NUCLEAR ENERGY INSTITUTE

SUBJECT: Comments on Draft Fitness for Duty Rule, 10 CFR Part 26
(RIN 3150-AF12)

The following comments are submitted by the Nuclear Energy Institute (NEI) on behalf of the nuclear industry, in response to the request for public comment on the Nuclear Regulatory Commission's (NRC) proposed rule amending 10 CFR Part 26, Fitness for Duty Programs.¹ Comments in this letter focus on the rule language in Subpart I, Managing Fatigue. NEI comments on the drug and alcohol portions of this draft rule are being submitted separately.

Figure 2-1
Sleepiness and Sleep Deprivation
(From Belenky, 2003)

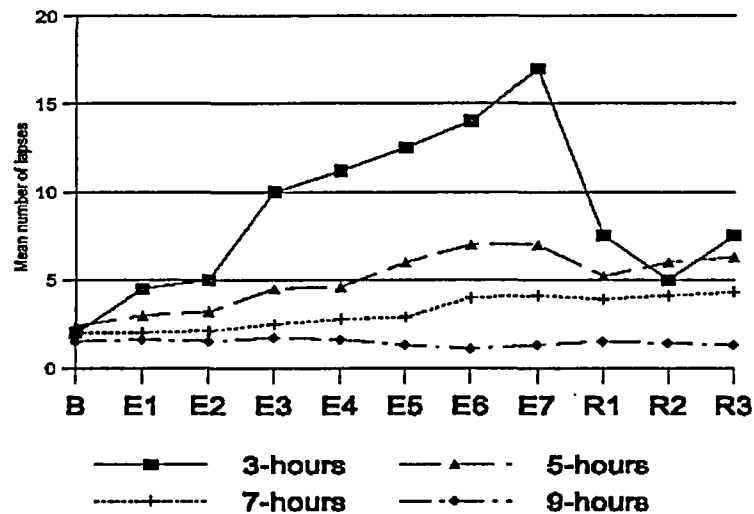
The rule package, Attachment 4, Addendum 1, provides data from a Belenky study performed in 2003. The rule package states “...use of the Belenky study in this analysis is expected to be a reasonable estimate of the performance improvement of mitigated fatigue in the nuclear power industry.” Figure 2-1(included below) from that study shows that individuals with a 9-hour rest remained at the baseline level of performance. The normal 12-hour break provides that rest opportunity.
